PUMP AND VALVE OPERABILITY  
SUMMARY FOR  
BYRON UNITS 1+2  
CAE/CBE

Subject Review of Seismic Report for Storage Battery & Battery  
Racks (1&2DC01EA,EB; 1&2DC02EA,EB)

Storage Batteries  
S&L Contract F/L 2819  
CECo P.O. Nos. 194757/194758  
Gould S.O. KE 5145, 5147, 5149, 5186

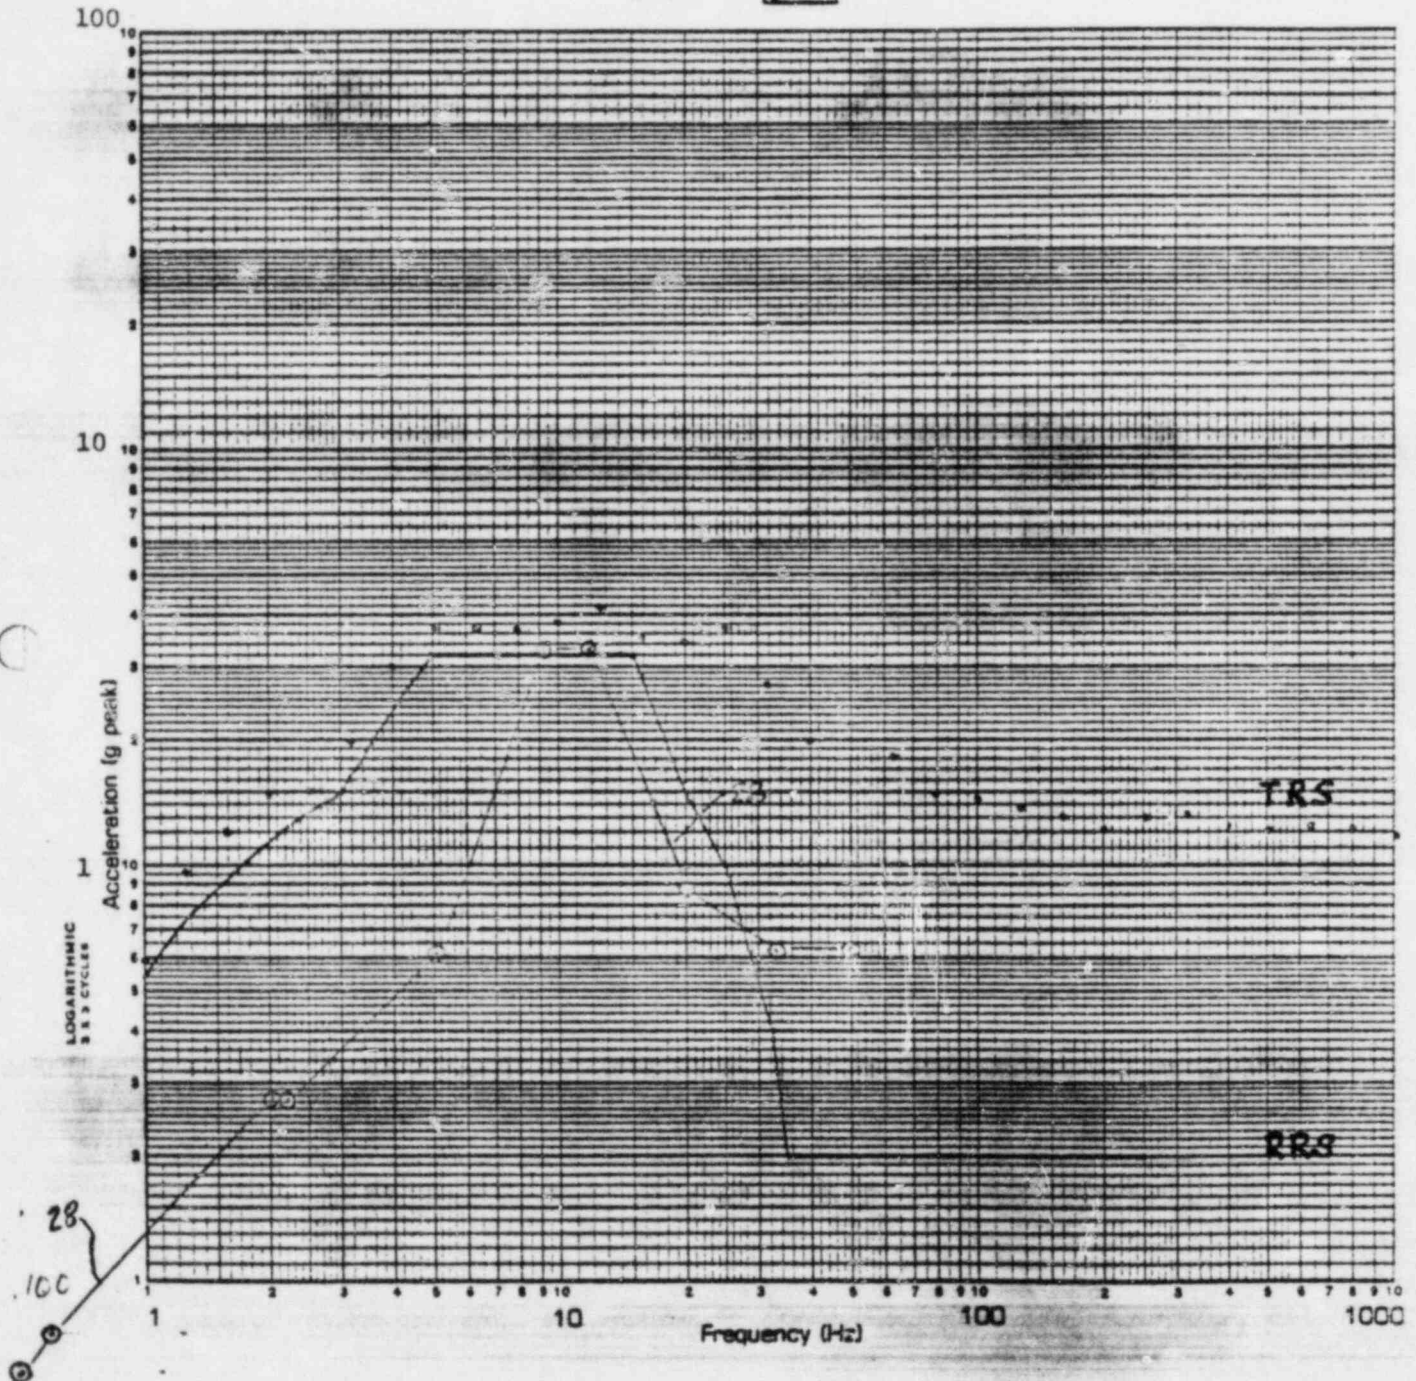
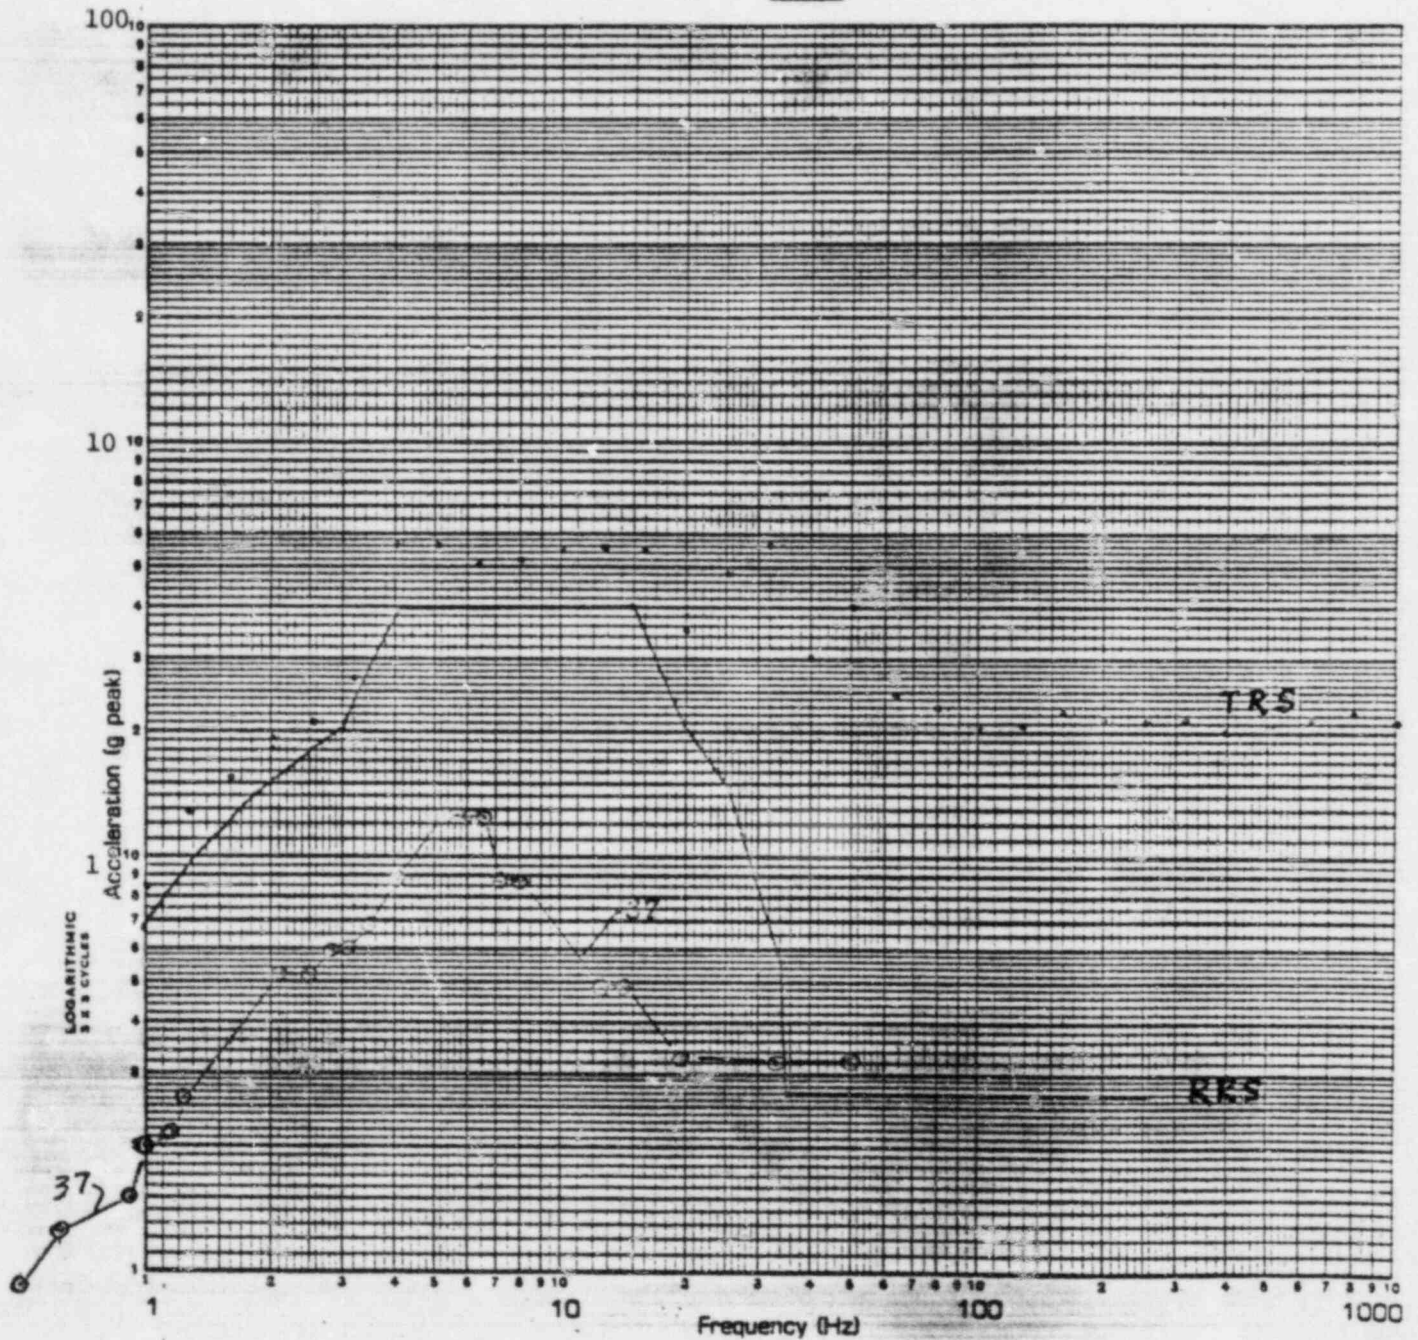
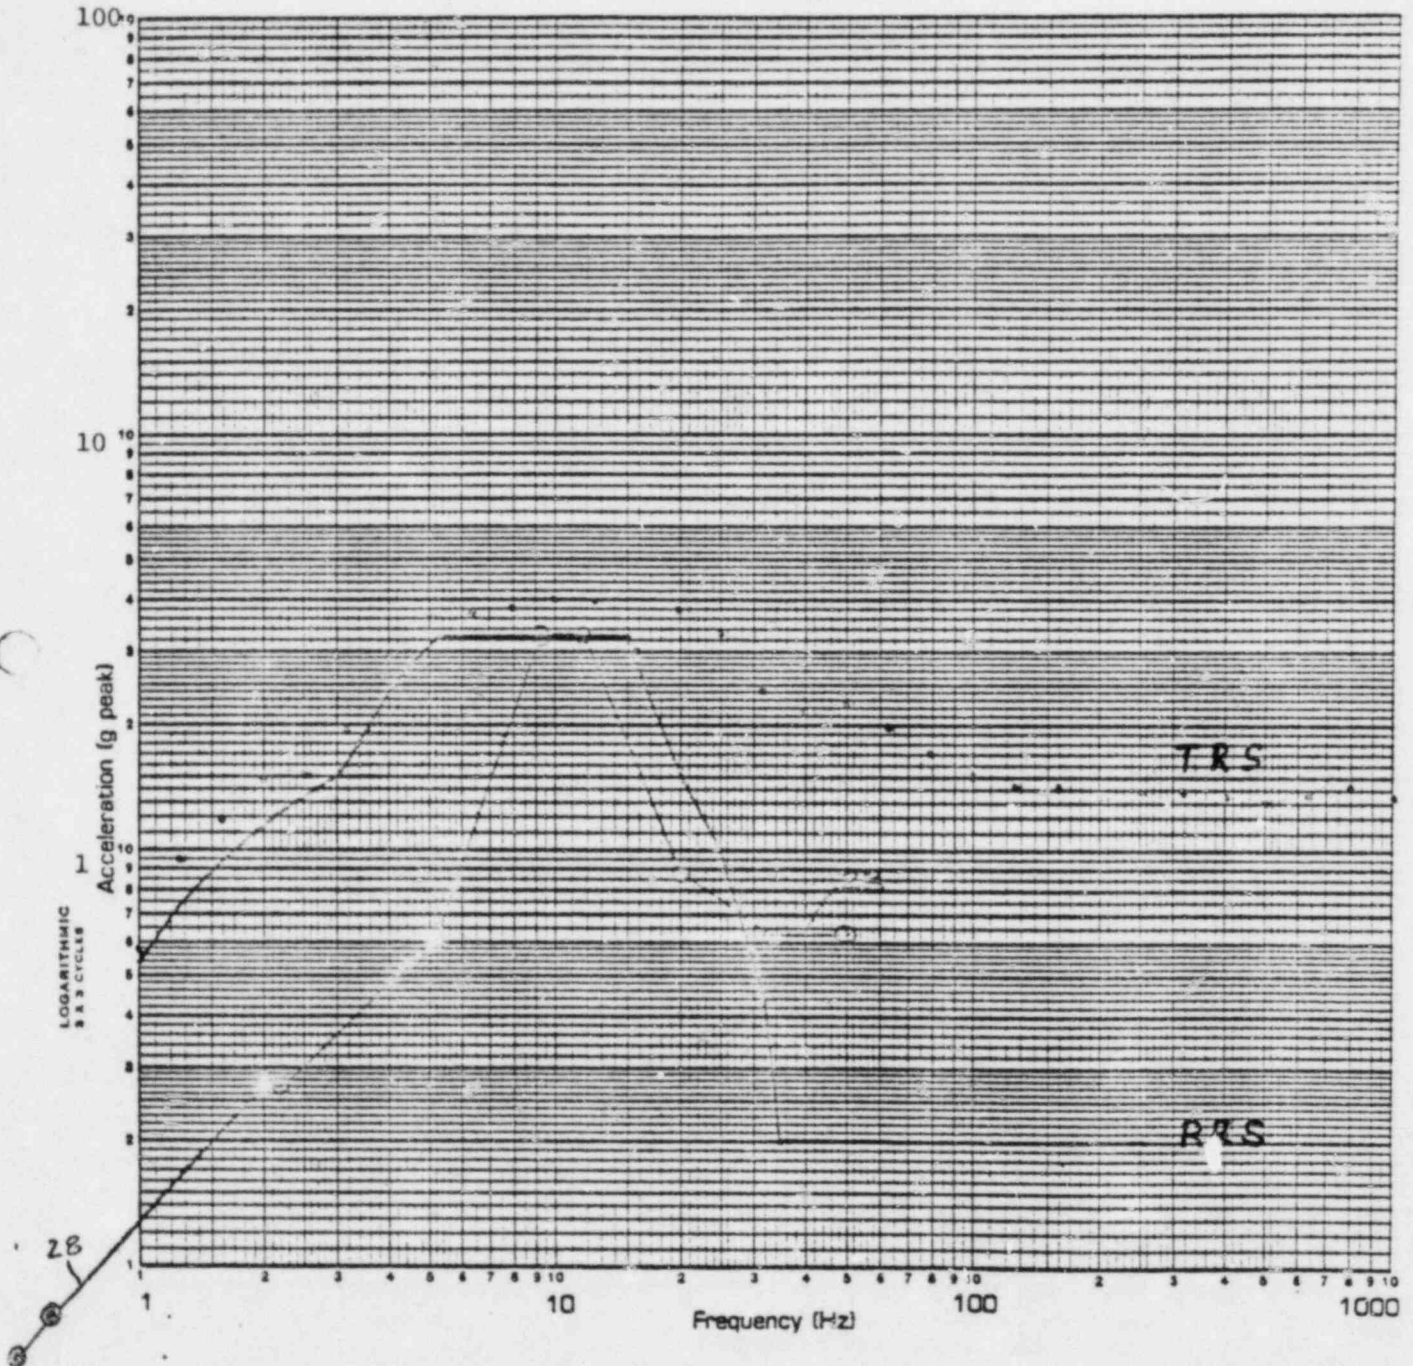
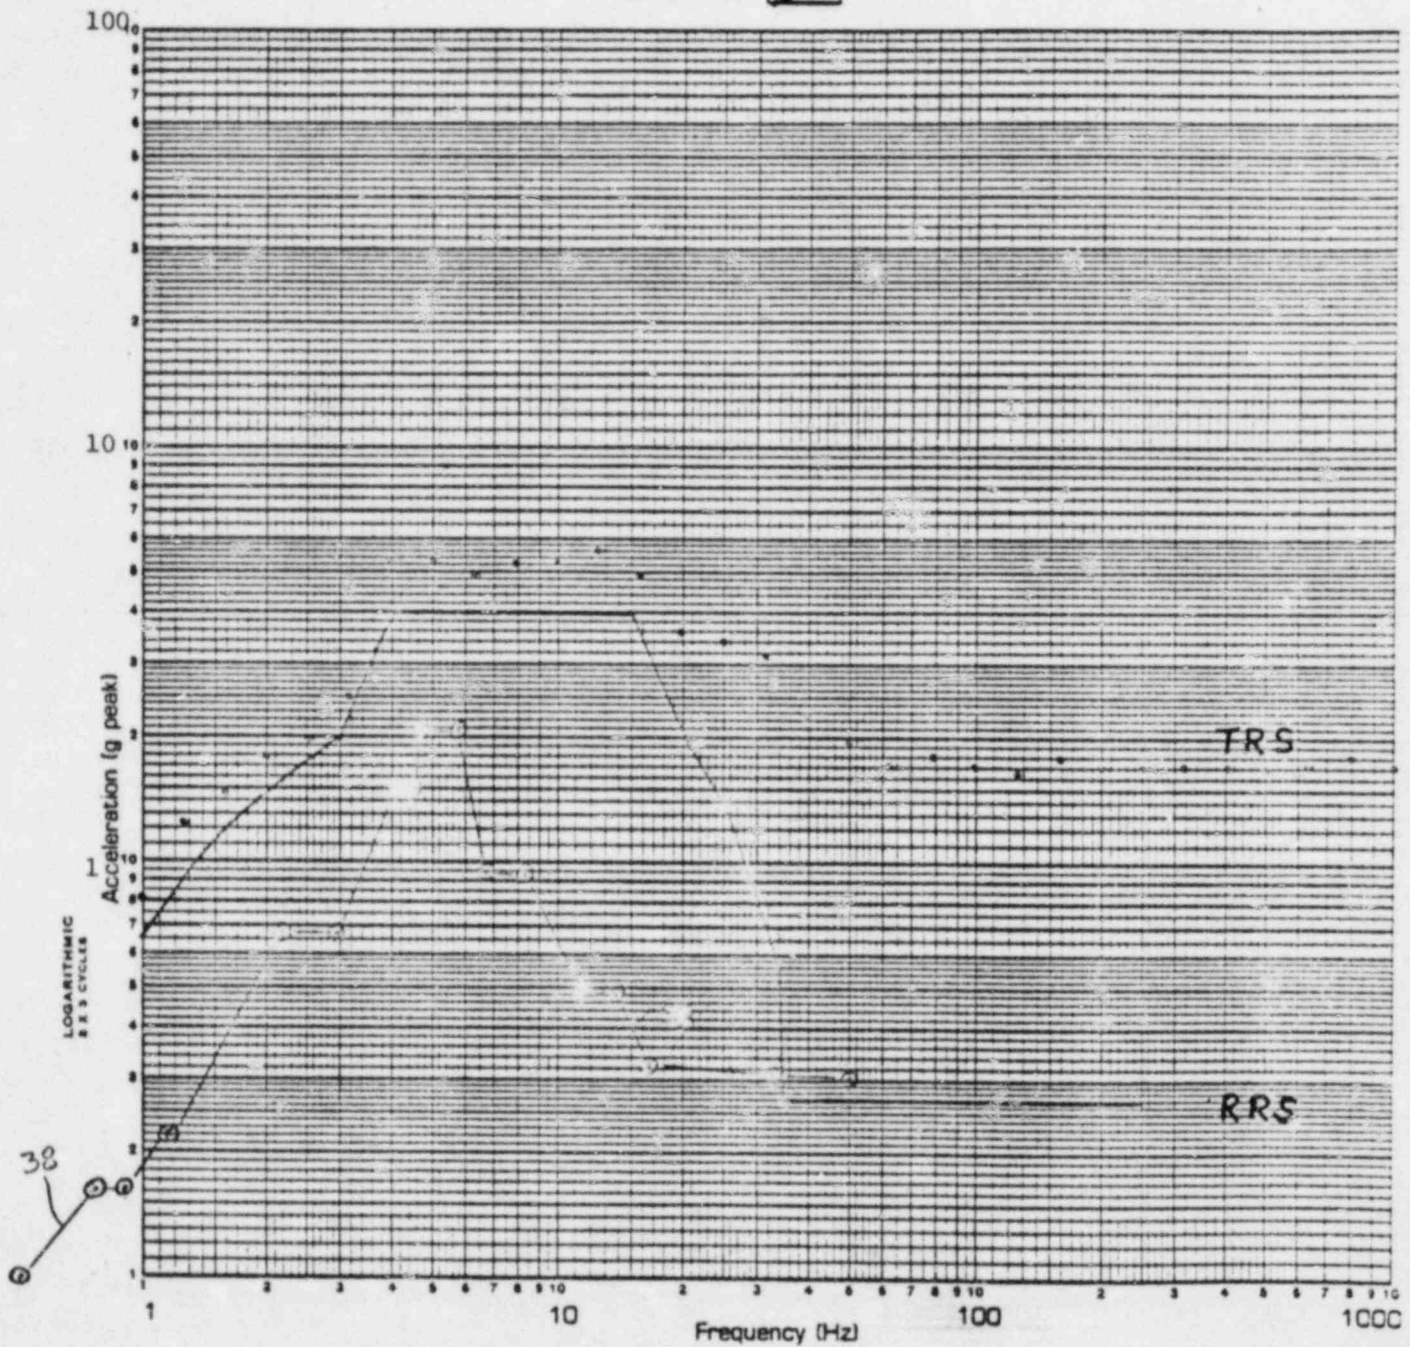
- c) Duration: 30 Secs.
- d) Does Test Response Spectra (TRS) envelop the Required Response Spectra (RRS)?
- ☒ Yes - Provide RRS and TRS as attachment
- ☐ No - Explain: \_\_\_\_\_
